HILLTOP GEOTECHNICAL
INCORPORATED

Project No.: 1664-01
Report No.: 2

Subject: **Addendum Report in Response to Fault Hazard Report Review, Proposed Convenience Store and Fuel Canopies, APN: 0601-543-01, Avalon Avenue, Yucca Valley, San Bernardino County, California.**

Subject: Fault Hazard Report Review

Site Plan and Exploratory Trench Locations APN 0601-543-01, Avalon Avenue, Yucca Valley	
	By: MC	Date: 9/2024
	Project No.: 1664-01.2	Plate No. 1

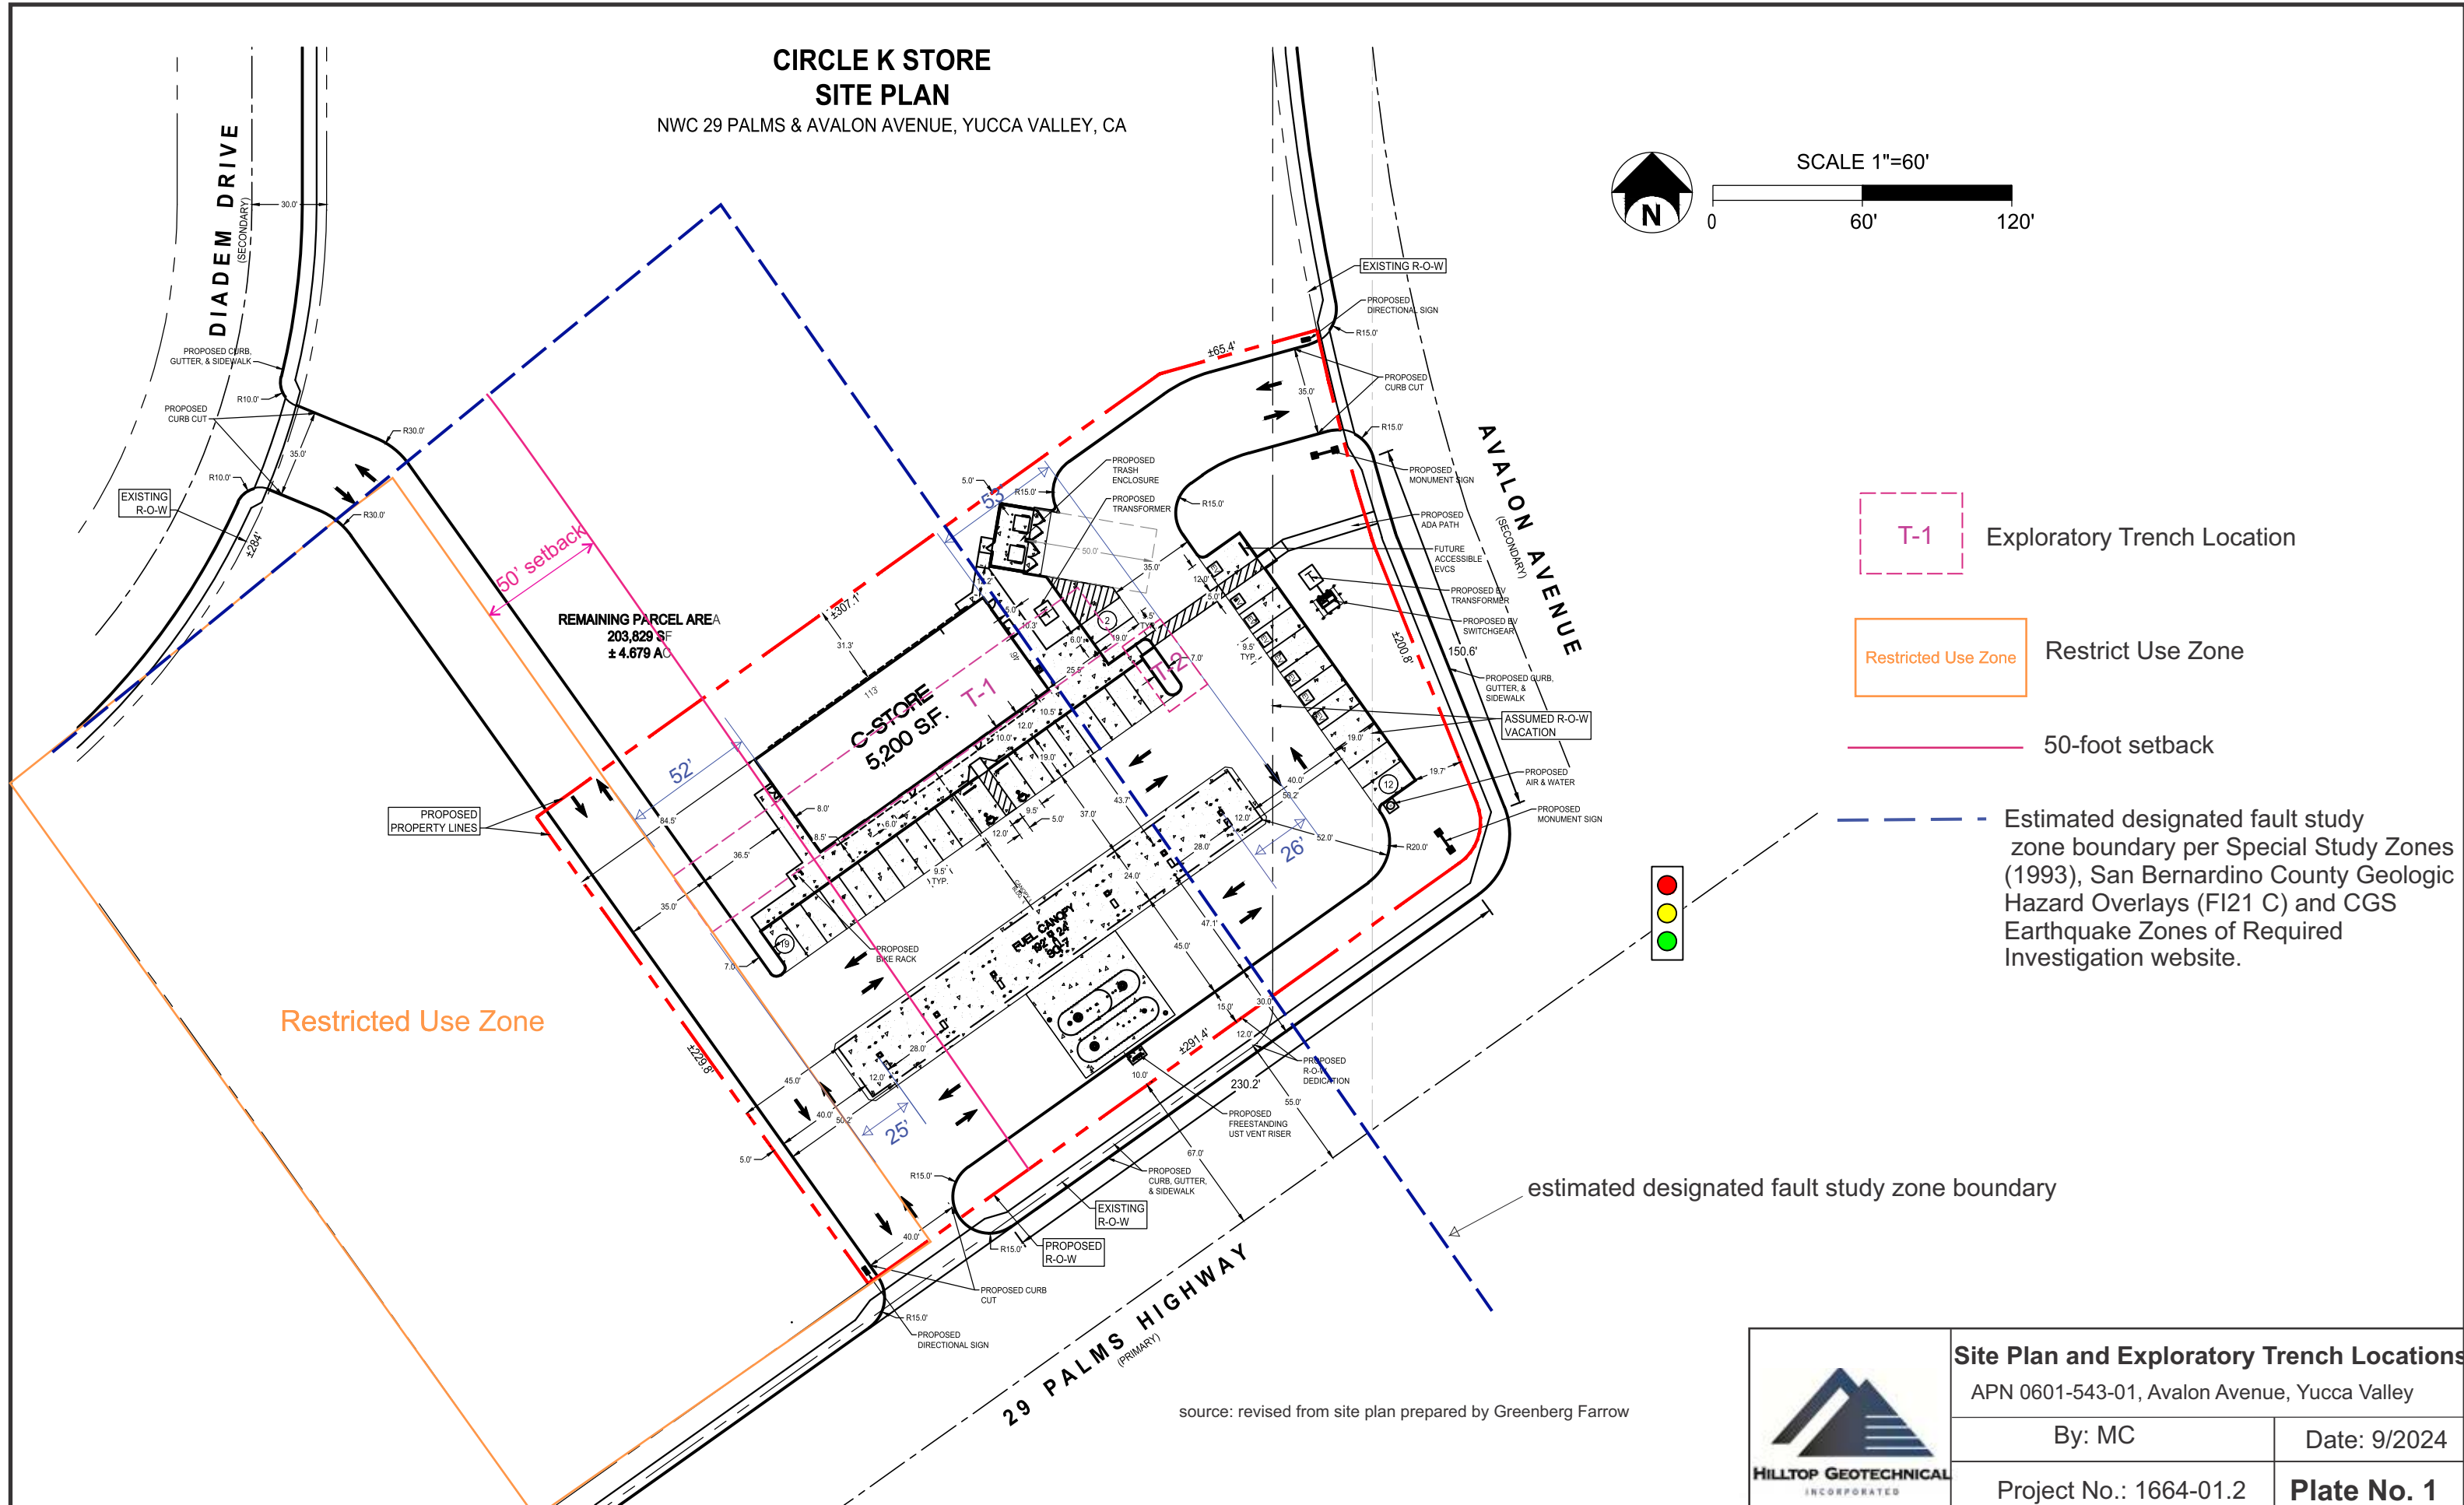
“Plate No. 1 Site Plan and Exploratory Trench Locations”

- a) Please provide a Site Plan illustrating the Restricted Use Zone (RUZ) for the entire project site. The setback and RUZ should be projected across the site. No habitable structures may be constructed within the RUZ unless further investigation indicates that Holocene active faults do not underly those portions of the subject property.

Based on Special Studies Zones-Yucca Valley North Quadrangle-Revised Official Map Effective: July 1, 1993, which is shown in Figure 4, only the west portion of the subject site was designated in a fault study zone. The site plan has been revised to illustrate RUZ and a 50-foot setback. No habitable structures shall be constructed within the RUZ unless further investigation indicates that Holocene active faults do not underly those portions of the subject property.

Site Plan and Exploratory Trench Locations	
APN 0601-543-01, Avalon Avenue, Yucca Valley	
By: MC	Date: 9/2024
Project No.: 1664-01	Plate No. 1

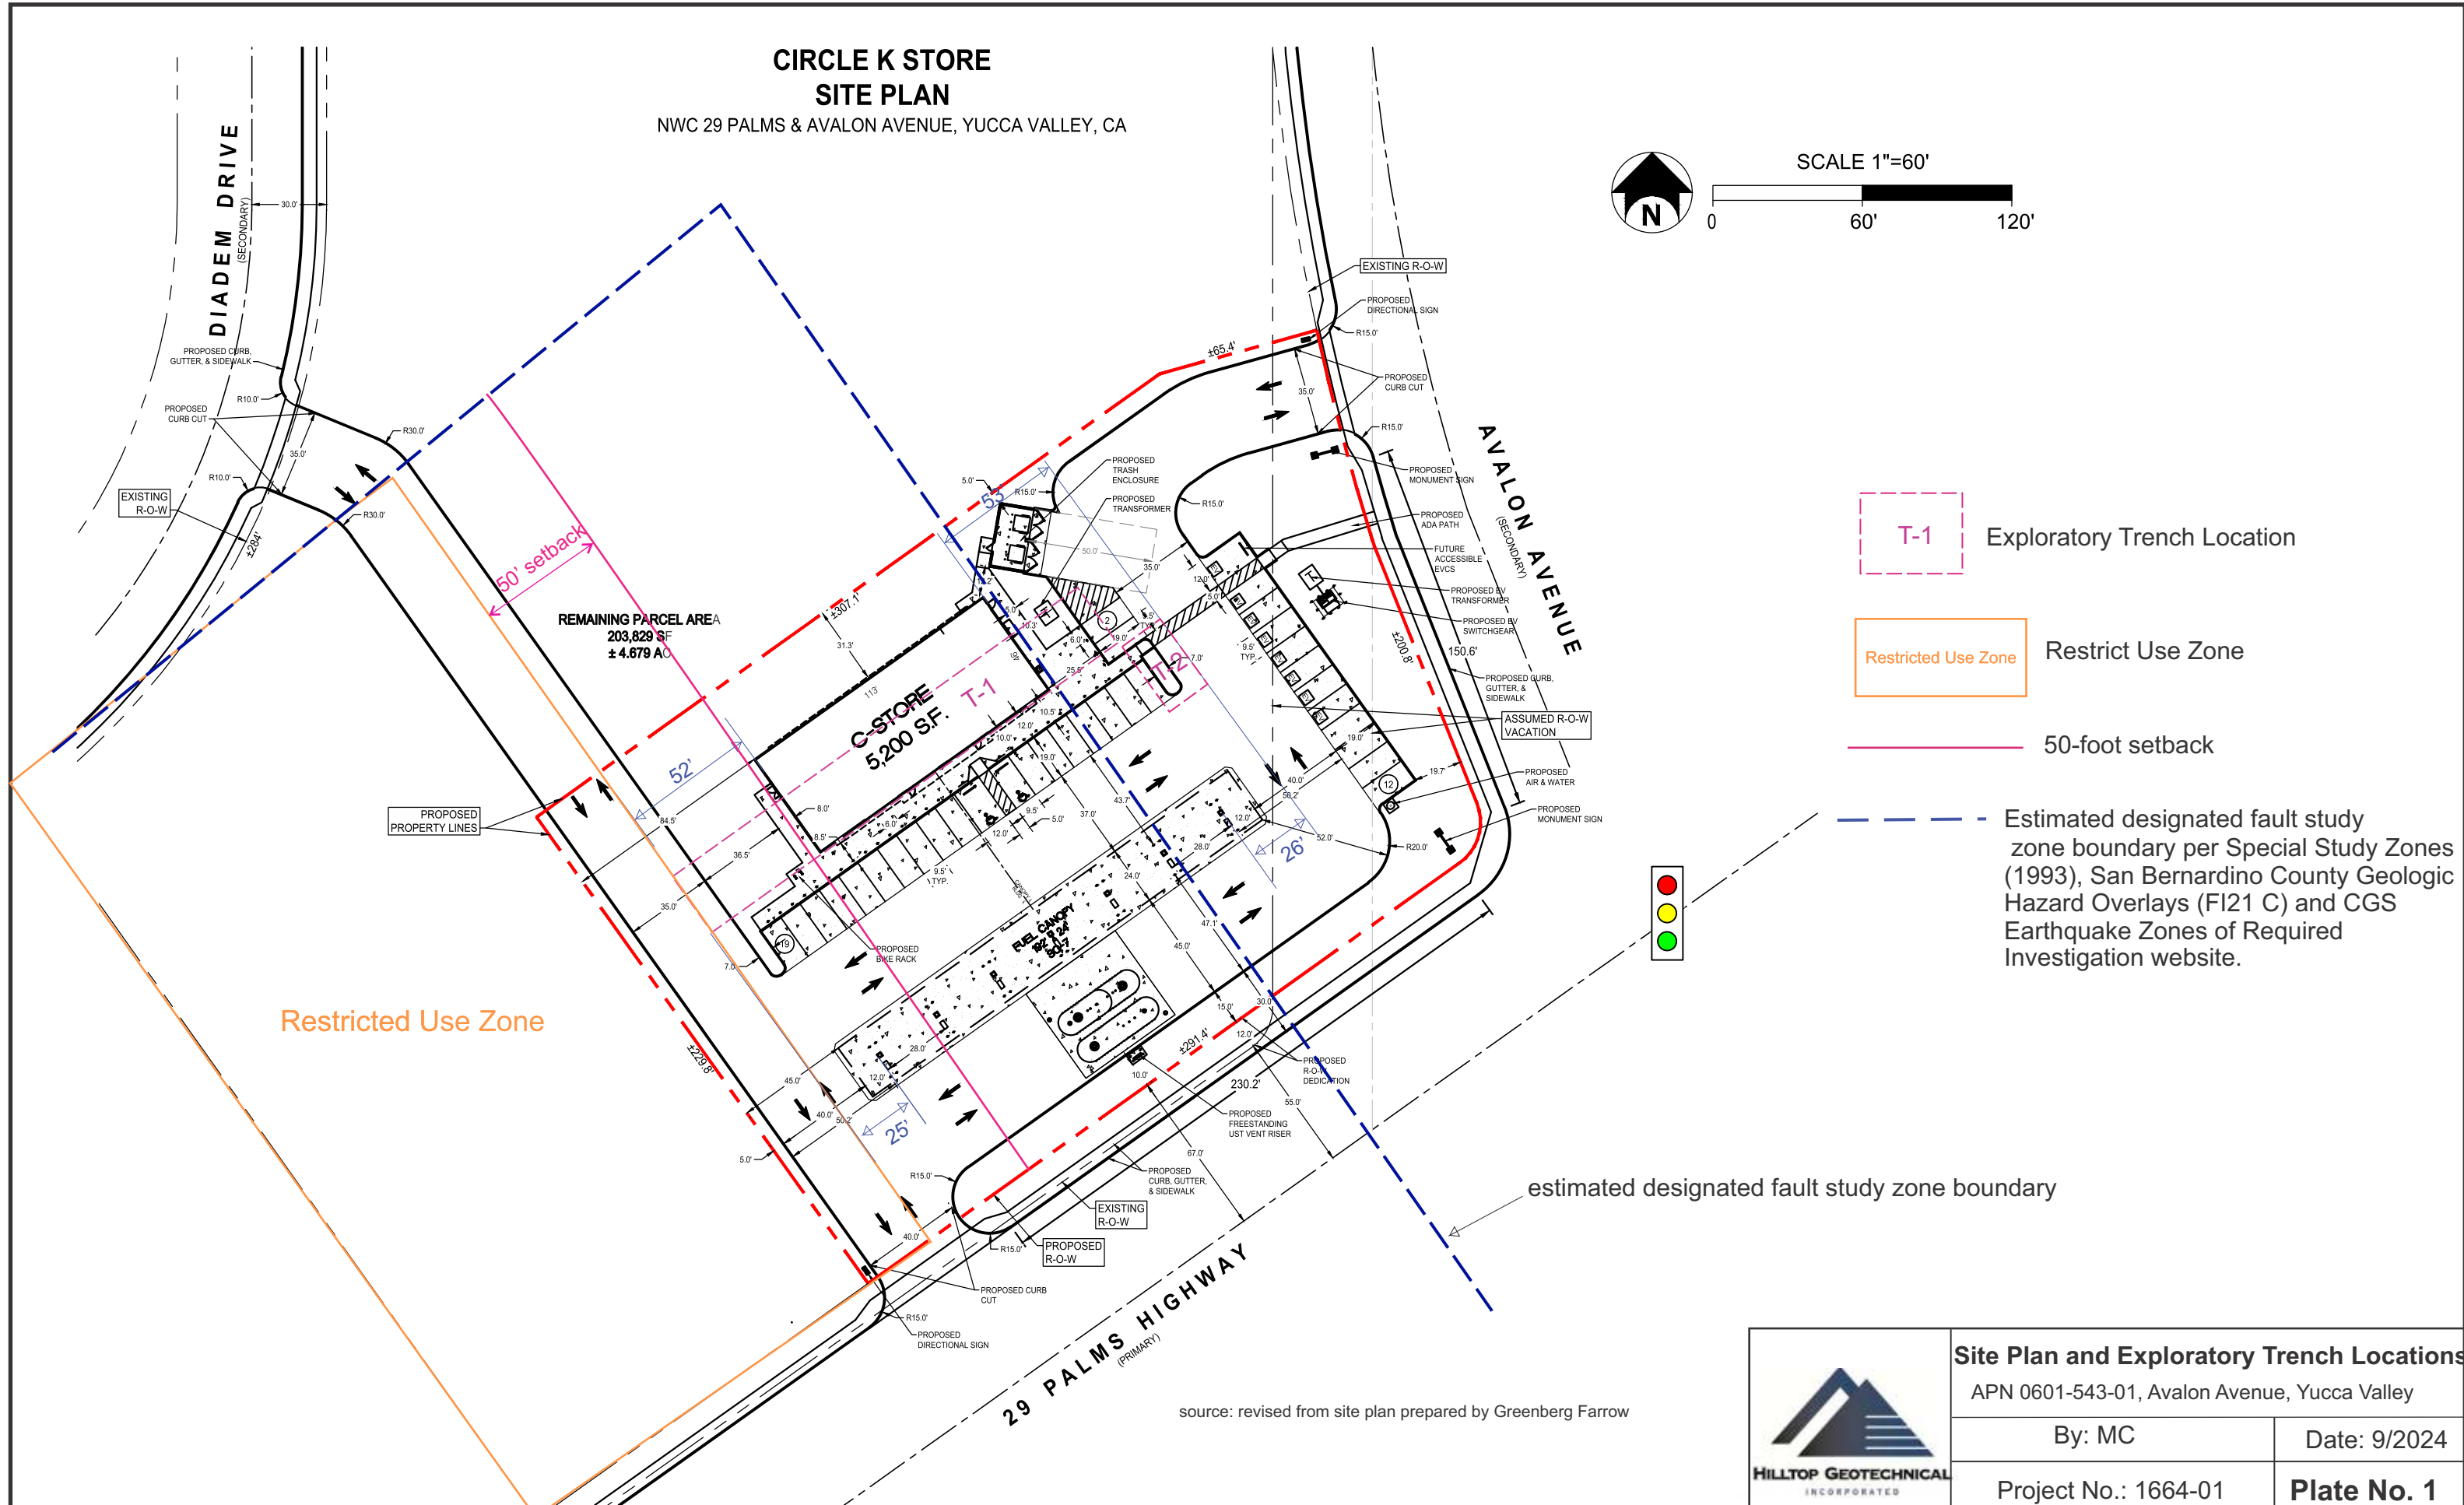
- 3) "Plate No. 1 Site Plan and Exploratory Trench Locations"
 - a) Please provide a Site Plan illustrating the Restricted Use Zone (RUZ) for the entire project site. The setback and RUZ should be projected across the site. No habitable structures may be constructed within the RUZ unless further investigation indicates that Holocene-active faults do not underly those portions of the subject property.
